A3 – Gr 21

Aim

The aim of this A3 is to provide support for the structural Bim analyst groups by providing feedback on their A3 scripts.

Gr 25

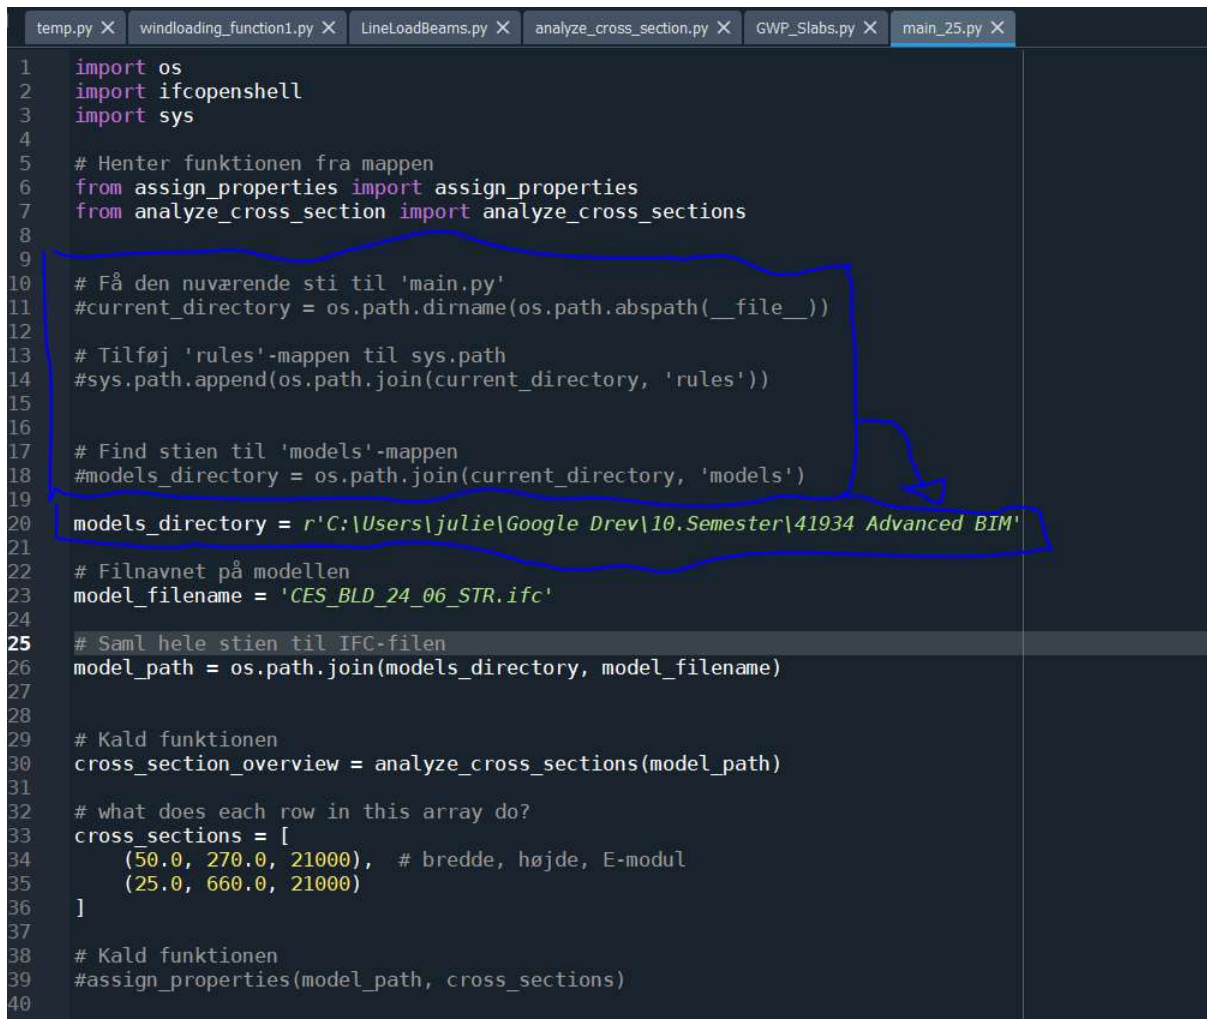
In GitHub, you A3 main script should be in the A3 folder

Also, maybe simplify the way the model path is located, to make it more flexible and transparent for others

I was confused about this part of the code. The input to your `assign_properties` function should be more clearly explained
